Work Order ID 98558

Item Name: Replacement Skidtube

DRAWING NO. D2580	TITLE 205 SKIDTUBE ASSEMBLY	REV. E	DART AEROSPACE LTD ENGINEERING ORDER	D.E.O. NO. D2580-E-1	SHEET NO. SHEET 1 OF 1	SCALE NTS
DRAWN <i>UP</i>	CHECKED <i>ASS</i>	MFG. APPR. <i>EC</i>	APPROVED <i>#</i>	DE APPR. <i>#</i>		
DATE 11.12.13	DATE 11.12.13	DATE 11.12.13	DATE 11.12.13	DATE 11.12.13

CHANGE ALL C'BORED WELDED CROSSBOLT SPACERS TO SWAGED SPACERS

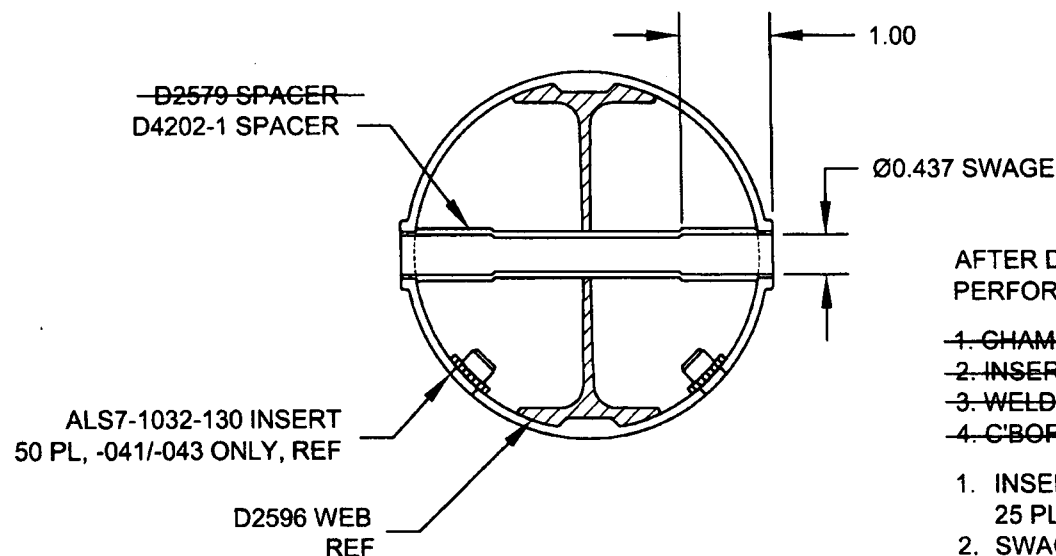
*** FOR -045 SKIDTUBE ONLY:**
WELD 4X D2579 SPACERS PER DWG
IN LOCATIONS MARKED "NO C'BORE".
REF SHEET 4 OF DWG.

AFTER DRILLING AND BENDING ASSEMBLY
PERFORM THE FOLLOWING FOR Ø0.508 HOLES ONLY:
